**THE REGIONAL MUNICIPALITY OF YORK
ADDENDA # 3
T-19-16**

FOR: Construction of Paramedic Response Station No. 29 at 107 Glen Cameron Road in the City of Markham

ARCHITECTURAL ADDENDUM 01

York Region Paramedic Response Station #29

3 / A7.1

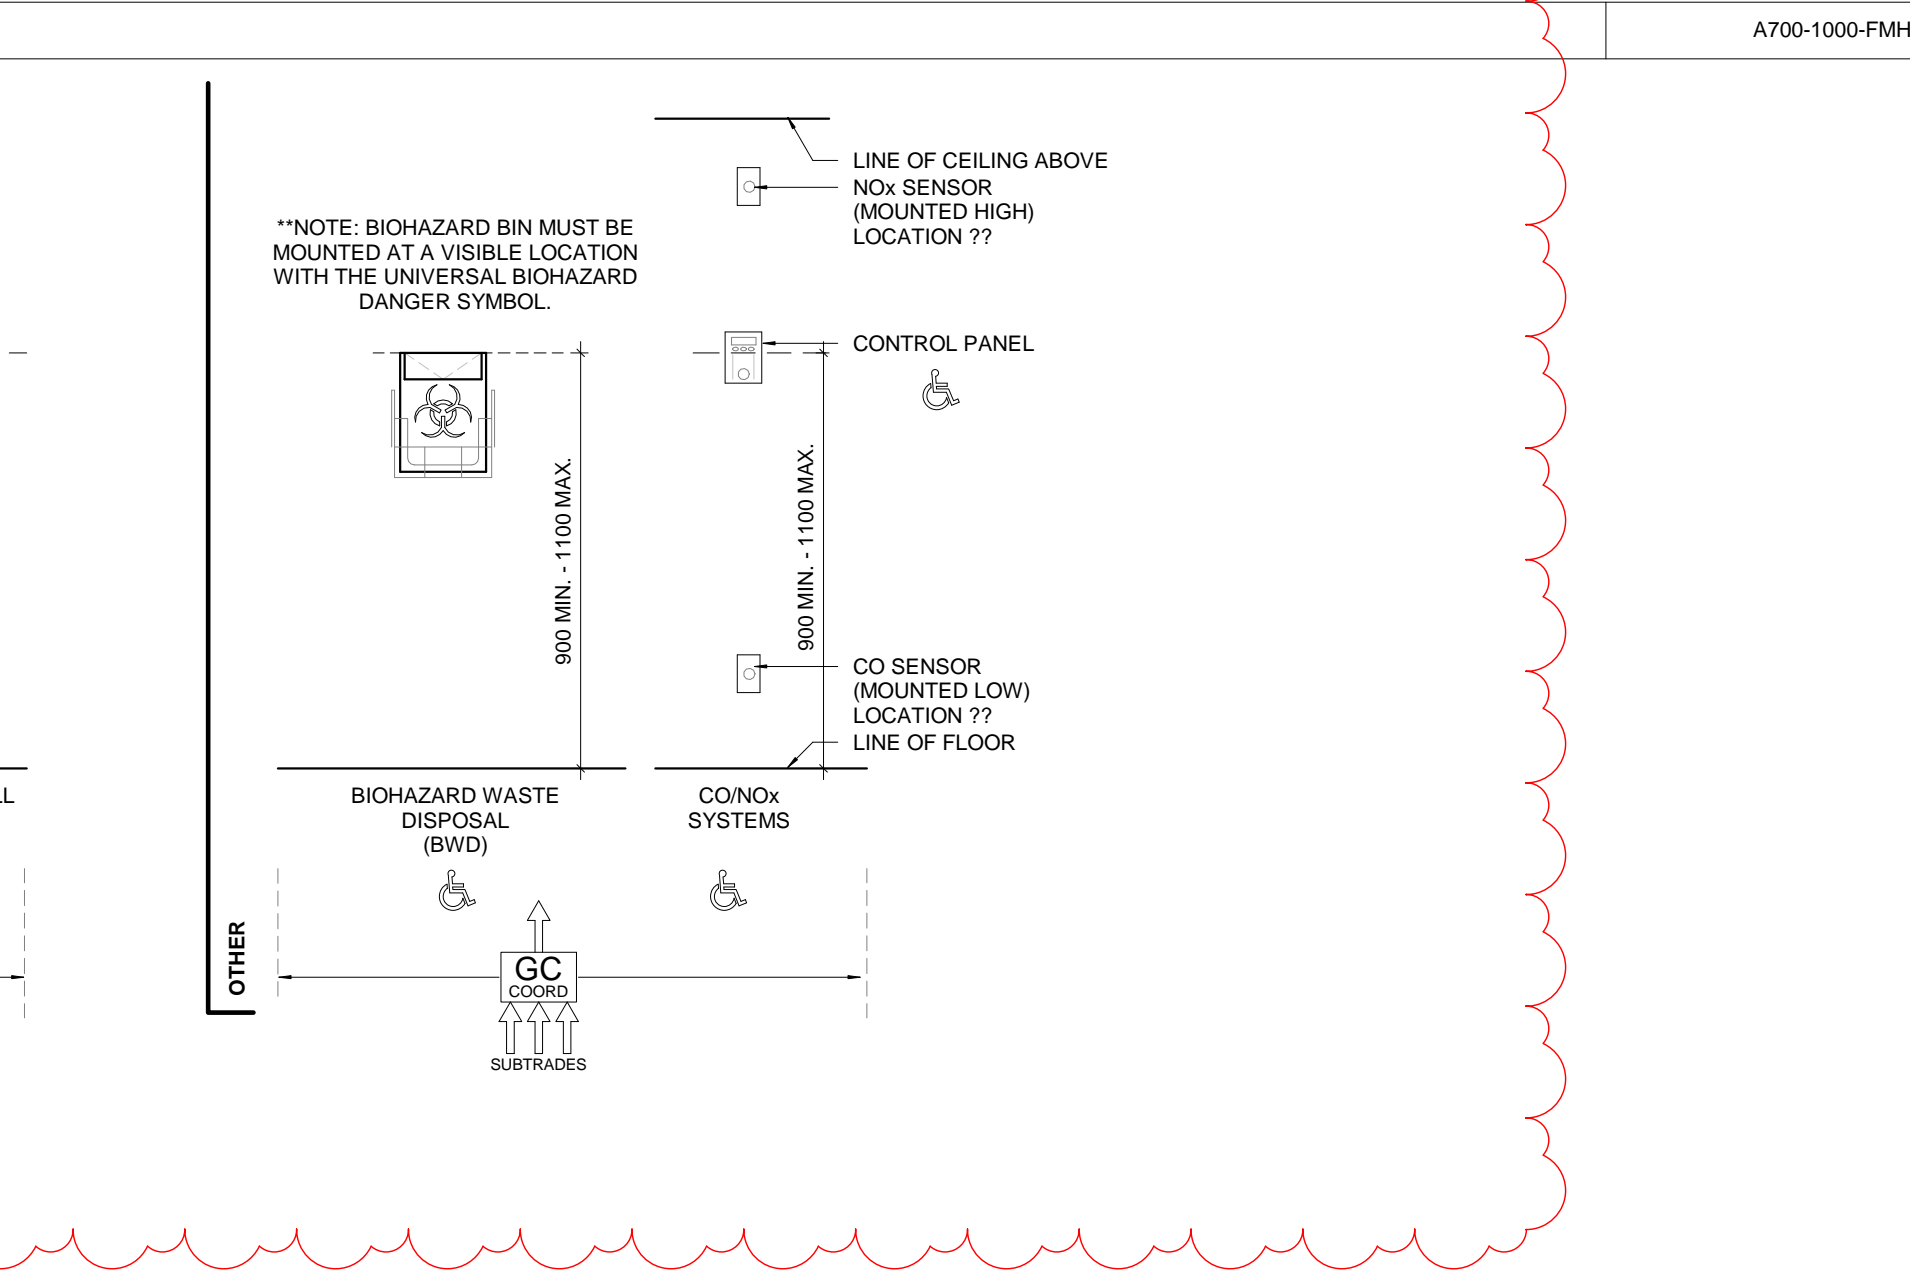
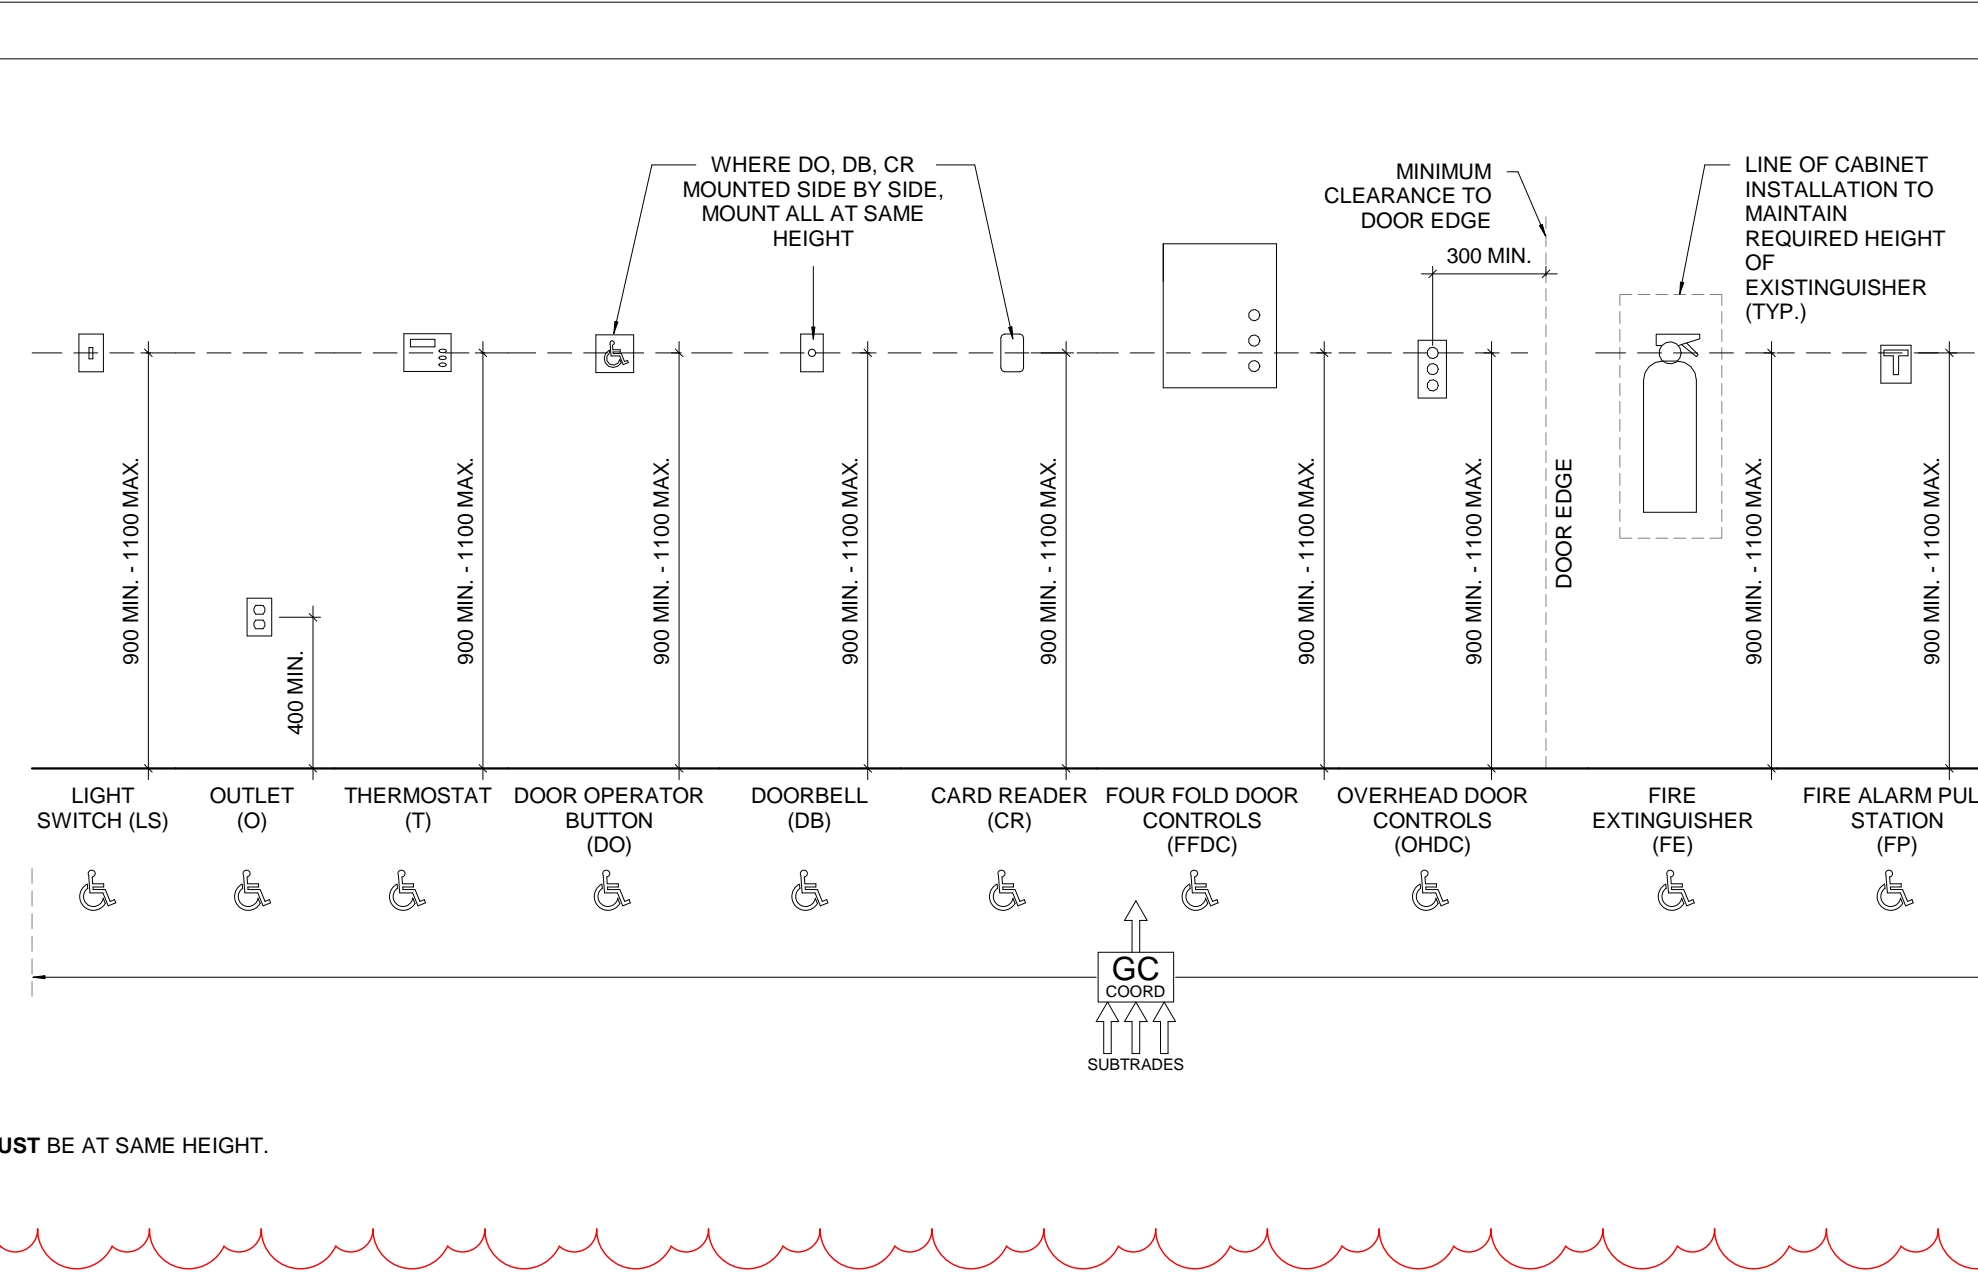
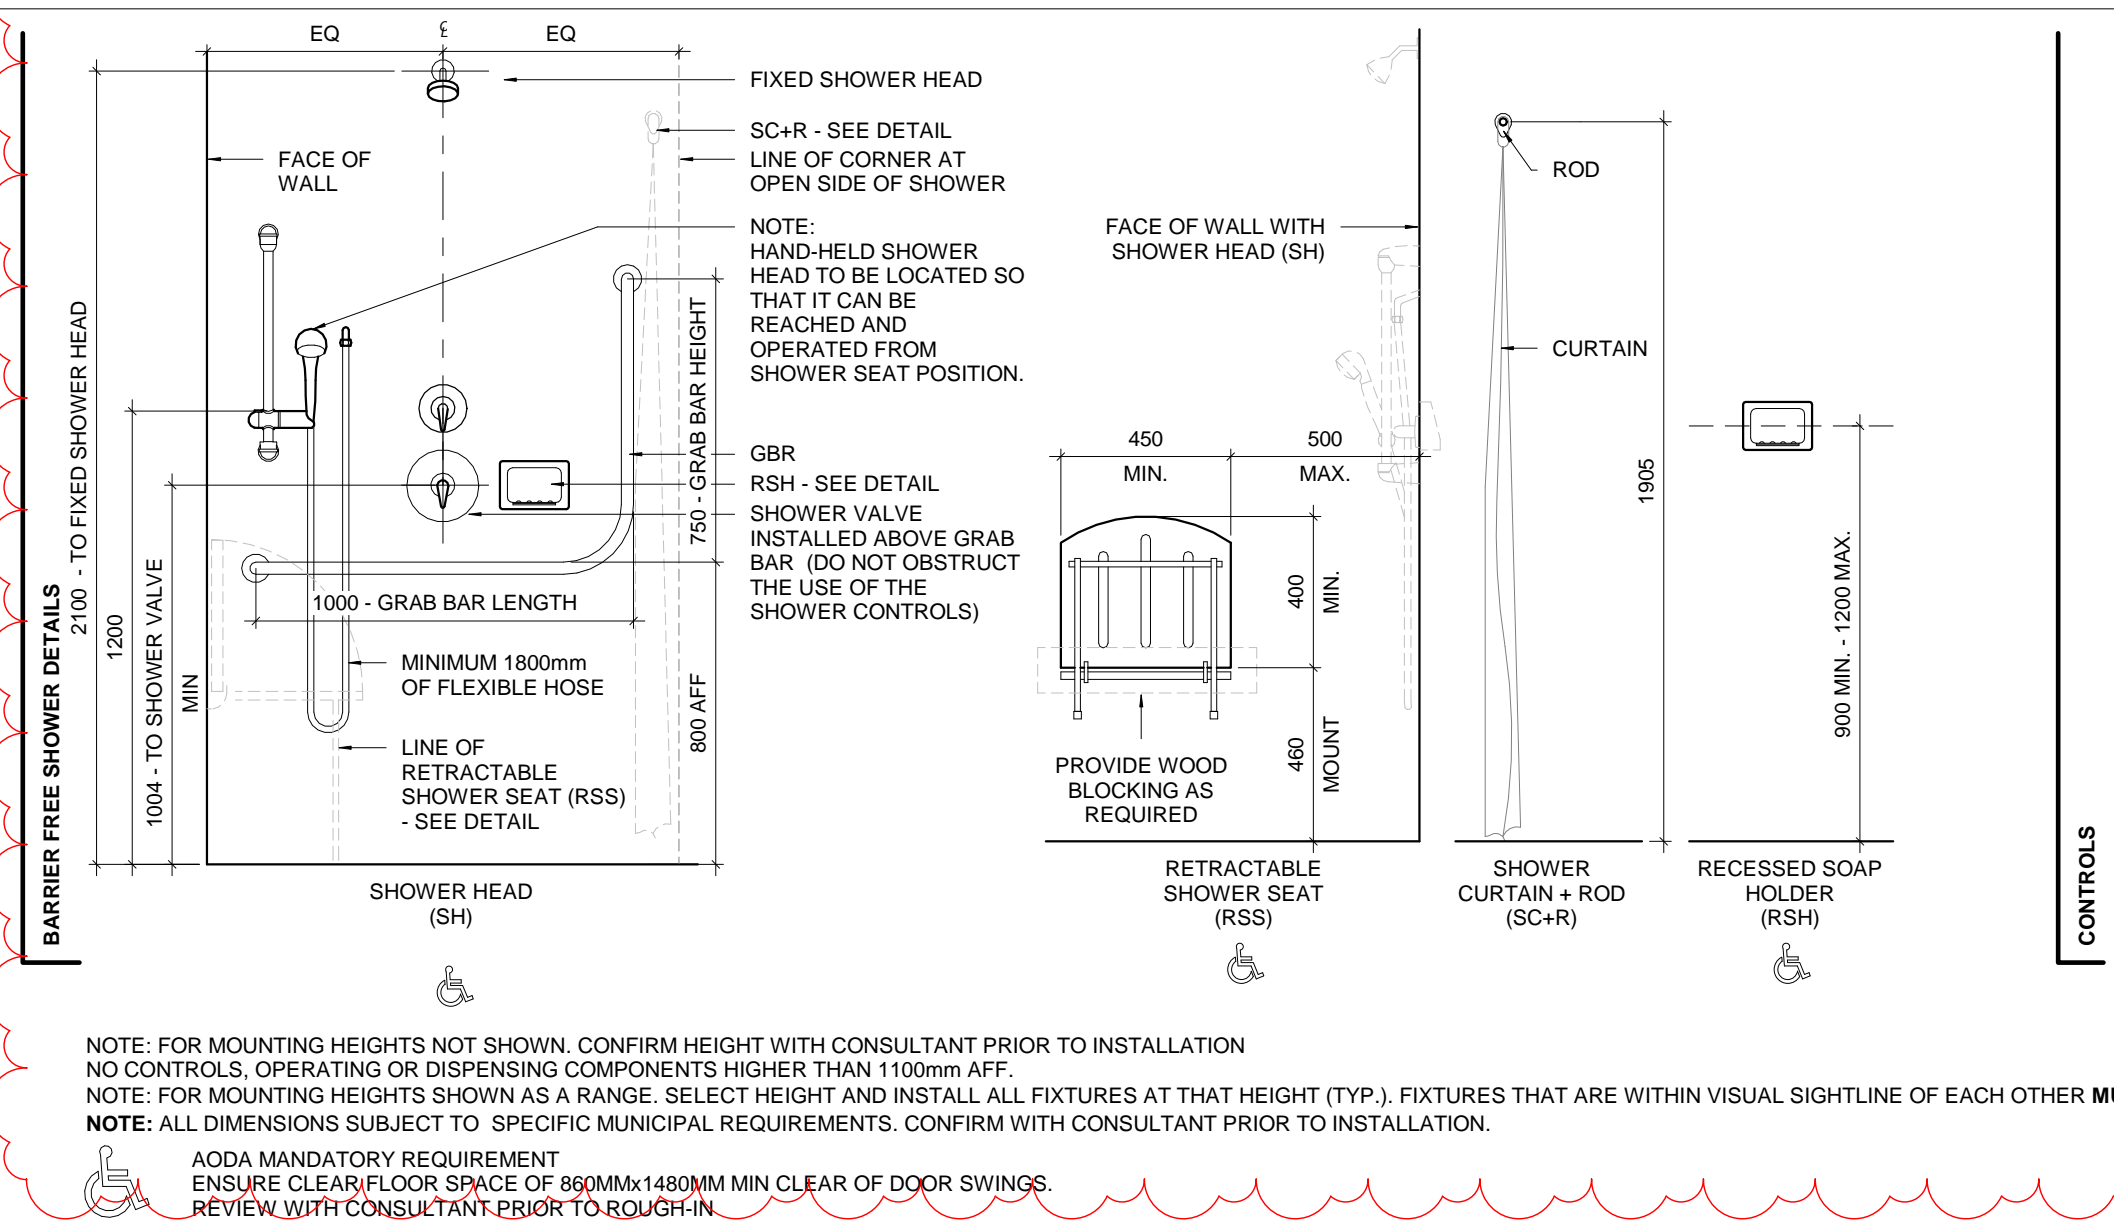
6. Refer to Drawing A7.1 – Washroom Details & Fixture Mounting Heights

- .1 Replace detail 2 and 3 with the revised versions, which are attached to this Addendum.

13 / A7.2

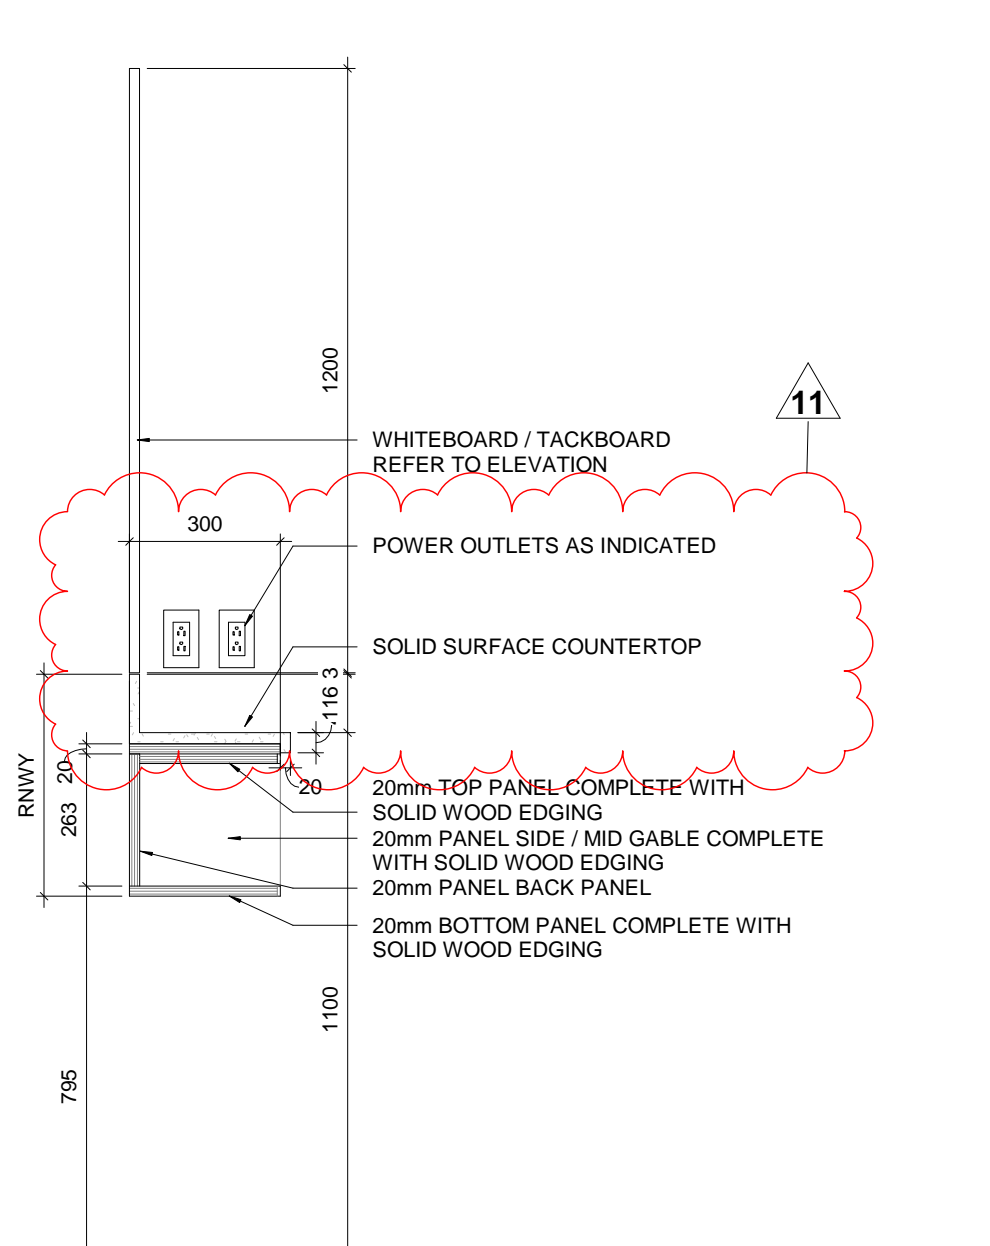
7. Refer to Drawing A7.2 – Millwork Plan, Elevations and Details

- .1 Replace detail 13 and 18 with the revised versions, which are attached to this Addendum.
